Project: Land South of Radwinter Road (East of Griffin Place), Saffron Walden

Planning Reference: UTT/21/2509/OP

Technical Note: Outstanding Highways Matters

Project No: CTP-20-1142

Please refer to the following page for a plan illustrating the locations of the problems identified as part of this audit (location numbers refer to paragraph numbers in the report).

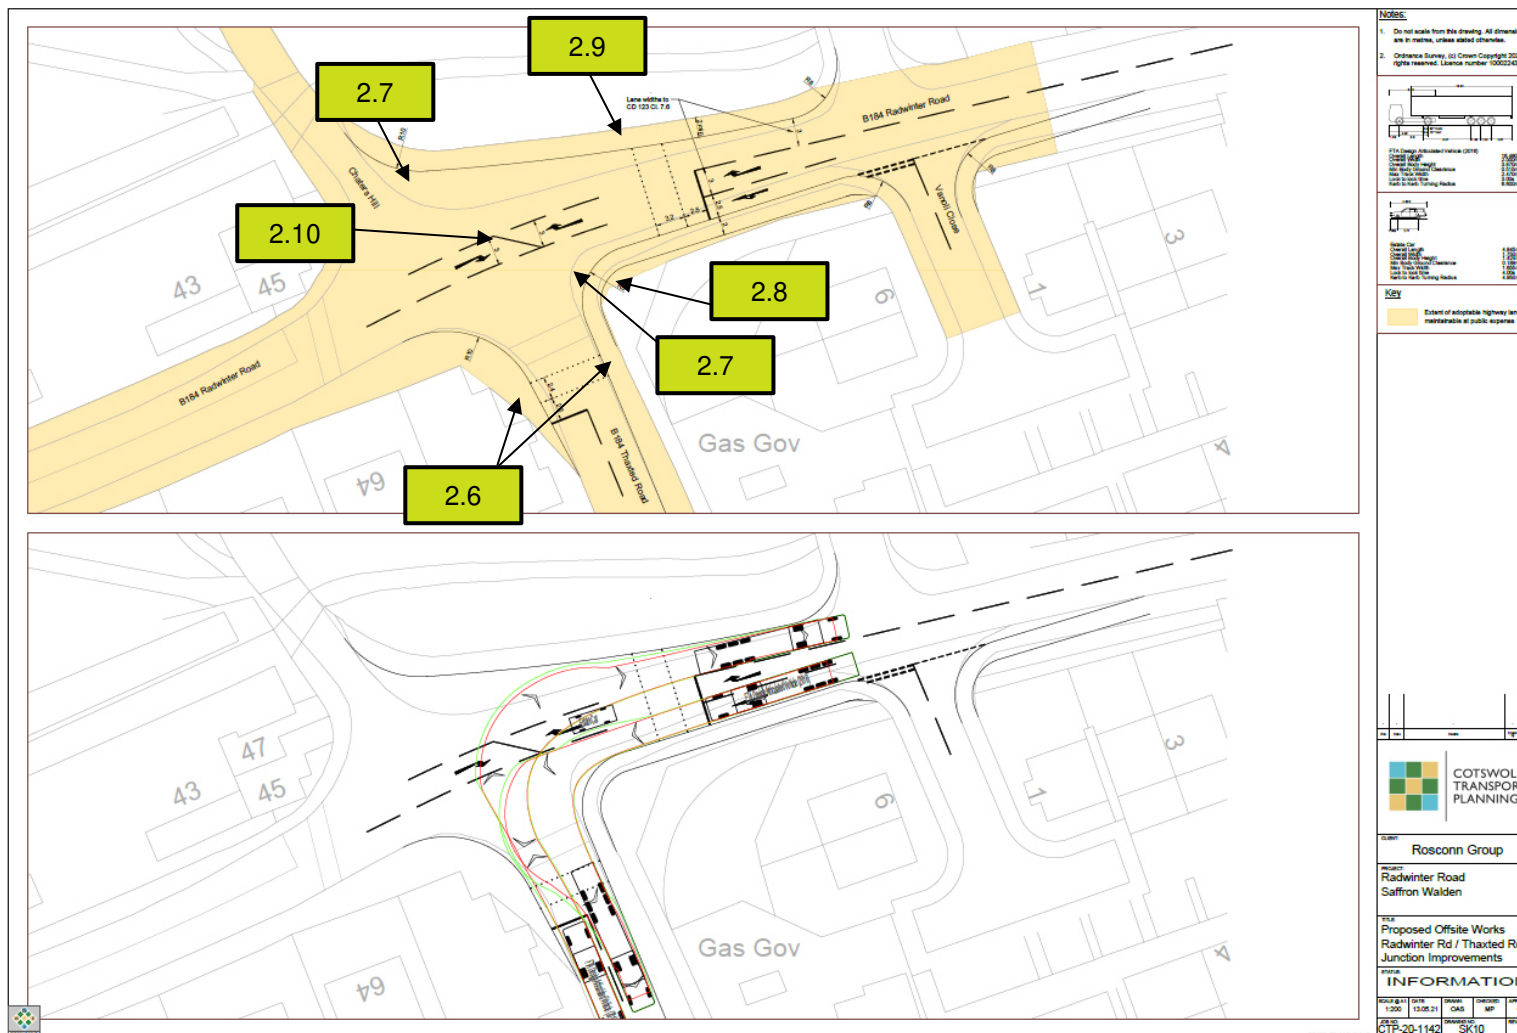
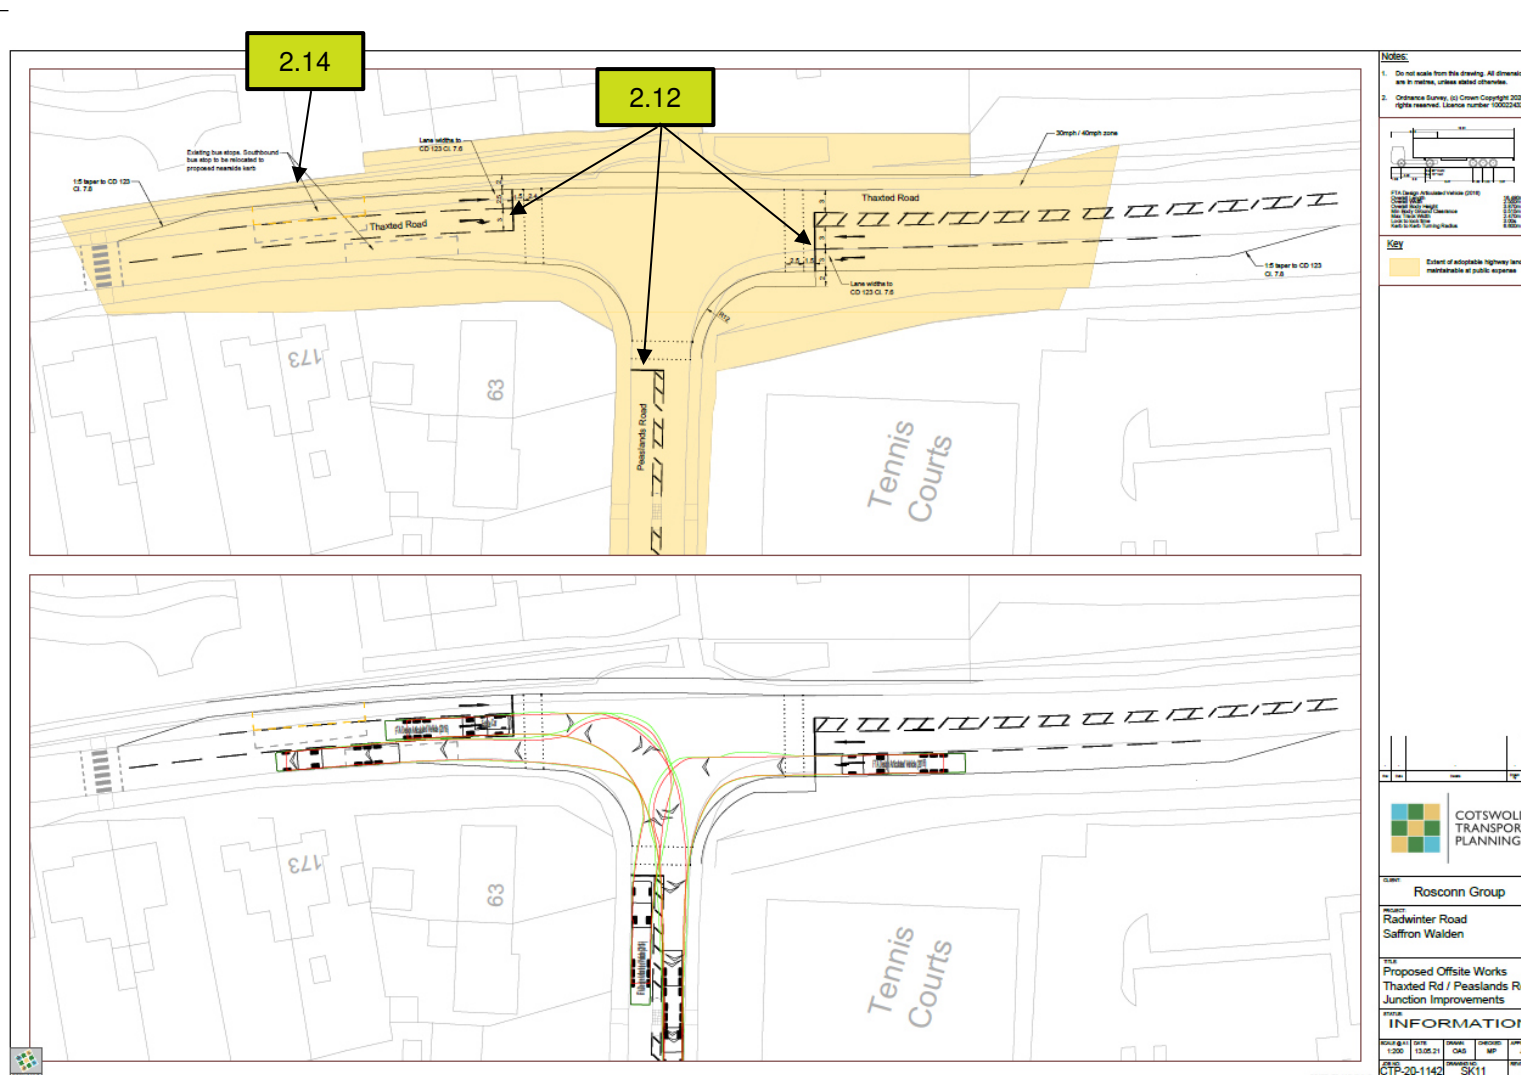
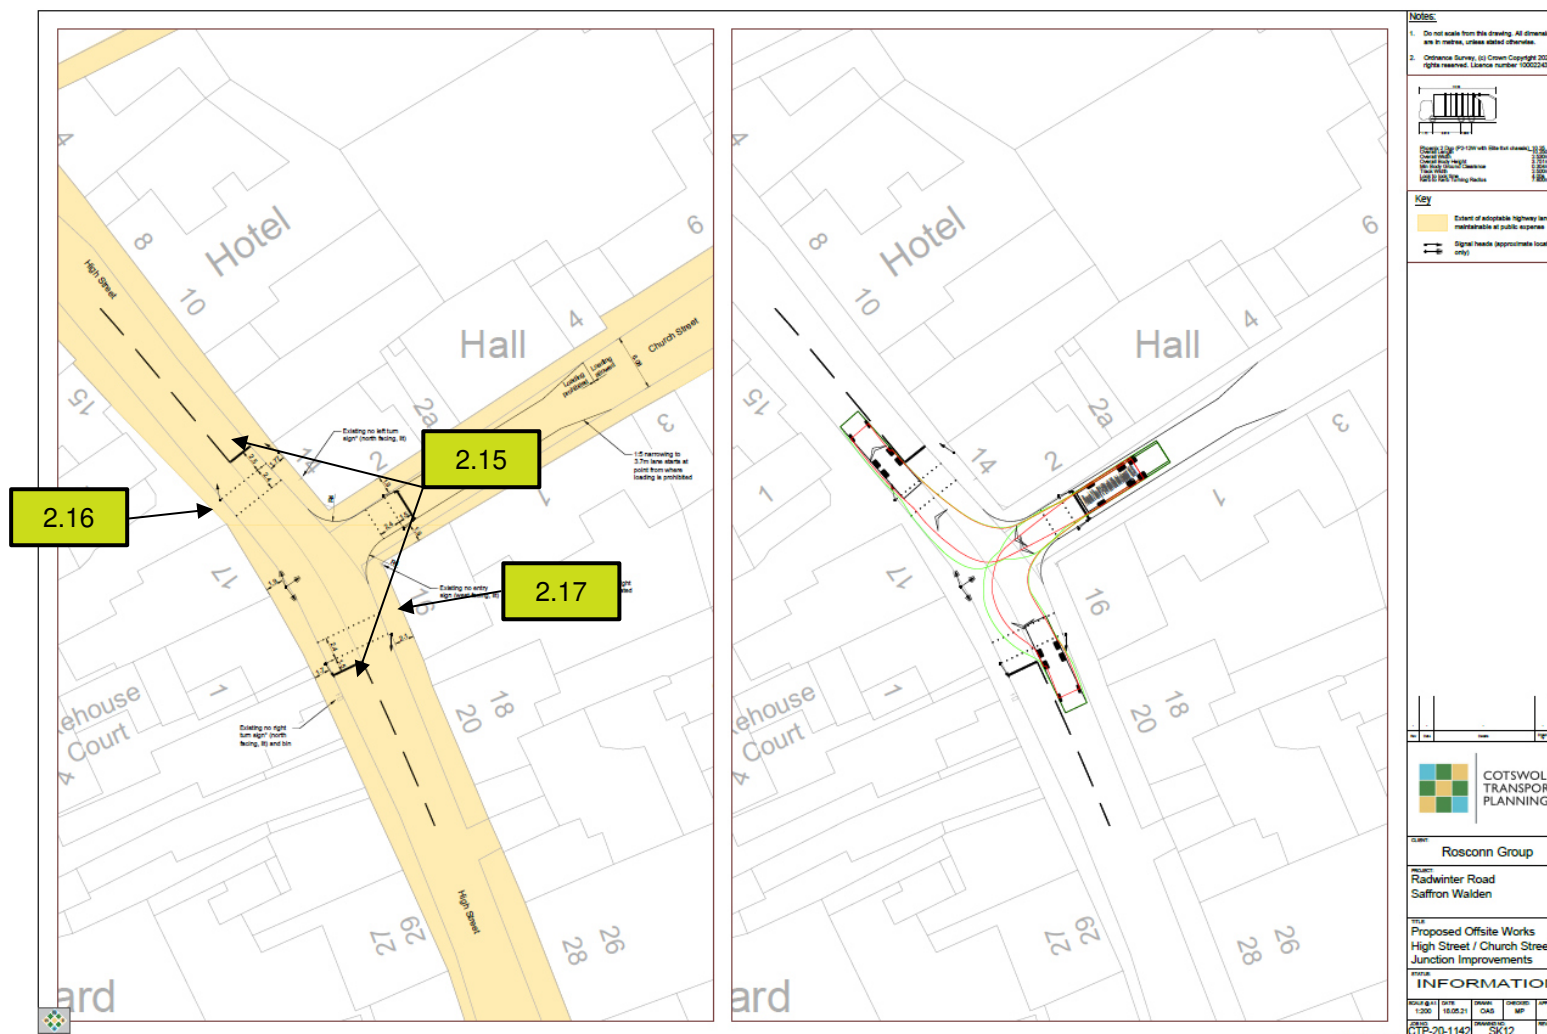
Paragraph Number	Problem	Accepted / Not Accepted	Recommendation	Designer's Response
Radwinter Road- Development Access				
2.1	<p>Location – Radwinter Road – pedestrian crossing</p> <p>Summary: The island presents an inconspicuous hazard</p> <p>The proposed new pedestrian crossing is located within the national speed limit and outside of the existing street-lit area. It may not be conspicuous to approaching westbound drivers, who's vehicles could collide with the island, causing damage and loss of control.</p>	Accepted	The risk of collisions with the island should be mitigated, e.g. by extending the built-up area speed limit and street lighting to an appropriate point east of the proposed new refuge island and by providing illuminated or reflective bollards on the island.	<p>It has been agreed in principle with ECC Highways that the speed limit on Radwinter Road can be reduced to 40mph between Saffron Walden and Swards End, and it would be the intention to seek to extend the 30mph speed limit area further to the east to include the proposed site access and bus stops.</p> <p>In addition, lighting provision will be reviewed as part of the detailed design.</p>

2.2	<p>Location – Radwinter Road – eastbound bus stop</p> <p>Summary: Level difference presents a risk to bus boarders</p> <p>The existing footway on the north side of Radwinter Road, at the proposed location of the new bus stop, is significantly higher than the adjacent carriageway. Passengers attempting to board or alight from a bus may not be able to do so safely.</p>	Accepted	Footway levels and gradients should be adjusted to provide a safe boarding area.	Footway levels and gradients will be reviewed as part of the detailed design of the proposed works and any adjustments required to provide safe boarding and alighting of buses will be incorporated into the design.

2.5	<p>Location – Radwinter Road – side road junctions</p> <p>Summary: No crossing facilities shown</p> <p>At this stage of the design, no dropped kerb crossing facilities are shown where the proposed new footway crosses existing side road junctions. In the absence of dropped kerbs, pedestrians with mobility impairment may not be able to cross the junctions safely.</p>	Accepted	<p>Dropped kerbs and appropriate tactile paving should be provided where the footway crosses side road junctions.</p>	<p>Dropped kerbs and tactile paving as requested have been shown on the revised site access drawing (CTP-20-1142-SK01 Rev D).</p>
-----	---	----------	---	---

2.16	<p>Location – High Street – north side of junction</p> <p>Summary: pedestrian crossing conflicts with vehicle access</p> <p>The west side of the proposed pedestrian crossing coincides with a dropped kerb vehicle crossing into a private access (Raynhams). There is a risk of collisions between pedestrians using the crossing and vehicles turning into or out of the access; the extended dropped kerb could be confusing for sight impaired pedestrians; and tactile paving laid at the crossing point is likely to be overrun and damaged by turning vehicles.</p>	Accepted	The pedestrian crossing should be relocated clear of the vehicle access.	<p>It is not possible to relocate the pedestrian crossing clear of the vehicle access without also relocating the stopline, which would reduce the junction inter-visibility zone further.</p> <p>The pedestrian crossing has been removed from this approach to the junction. This is shown on the revised layout (Drawing No. CTP-20-1142 SK12 Rev A).</p> <p>Pedestrians would have controlled crossing facilities of the High Street on the southern arm of the junction. Currently there are no dedicated pedestrian crossing facilities at this junction.</p>

2.17	<p>Location – High Street – south side of junction</p> <p>Summary: pedestrian crossing conflicts with steps across footway</p> <p>The east side of the proposed pedestrian crossing coincides with a narrow section of footway adjacent to some stone steps outside the door of No.16 High Street. The stone steps could present a trip hazard to pedestrians using the crossing and could restrict the tactile paving layout. Together with the proposed signal post, they will restrict the passage width along the footway such that a pedestrian may be obliged to walk in the carriageway where they could be struck by a passing vehicle.</p>	Accepted	The pedestrian crossing and signal post should be relocated clear of the stone steps.	The position of the pedestrian crossing will be reviewed as part of the detailed design to seek to avoid conflict with the stone steps.
